**Design and Access Statement**  
**039; No.3 Belsize Park, London**

This Design and Access Statement has been prepared in support of the application for 'FULL' planning permission in relation to proposed development at Flat 3, 3 Belsize Park, London.

**RE: 2022/4645/PRE 3 Belsize Park**

Proposed Rear Elevation

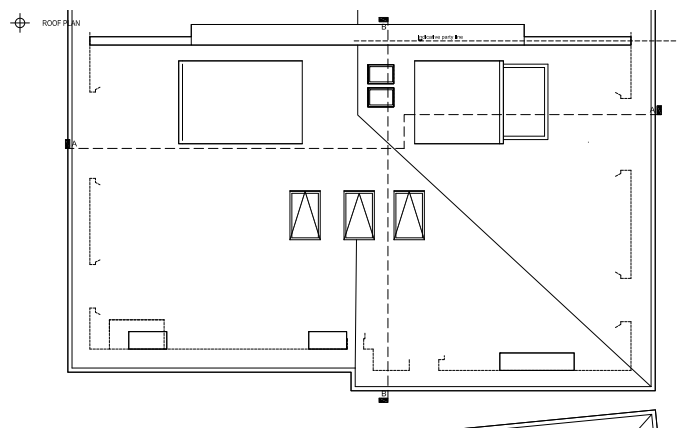
The rear dormer is being increased in width with a stepped-down design to fit under the side roof ridge. This extent of the increase in width is too significant and means that the dormer would no longer appear as a modest projection from roof level. A small increase in size may be acceptable but this should not be greater than the neighbouring dormer at no.4. The overall design also looks contrived, incongruous and bulky compared to the existing front dormer. Standing seams are not typically used for dormers on traditional buildings. Dormer materials should complement the main building and wider townscape. Given the existing building stock, the use of traditional materials (timber, lead, hanging tiles) is encouraged. We would also expect the dormer to be appropriately fenestrated with window divisions to match neighbouring dormers. Similarly a small enlargement of the existing inset terrace may be supported but should not have projecting visible balustrades. The terrace should be similar to the size of the neighbouring terrace at no.4 Belsize Park.

The alterations are generally supported; however the size of the replacement dormer is too significant and both this and the enlarged terrace area should be reduced in size. The materiality of the dormer should be traditional and the windows should be traditional to match the character of the building.

- a) Photovoltaic slate tiles now annotated as 'grey' in colour.
- b) Width of dormer increased to align with No.4 (adjoining neighbour). This is wider than originally submitted, but aligns with the advice in that it will match the width of the immediately adjacent dormer.
- c) Cladding to altered dormer in traditional lead sheet.
- d) Width of terrace reduced to align with No.4.

- We are proposing glazing without decorative bars, mullions or transoms. This is because none of the nearby dormers have these features (as viewed on Google Earth), and the benefit will be substantial to the internal daylight of the bedroom.
- We wish to retain the projecting terrace balustrading which remains as previously approved under planning application 2017/4240/P. Unless planning policy has changed in the intervening period, we trust that this proposal remains acceptable.
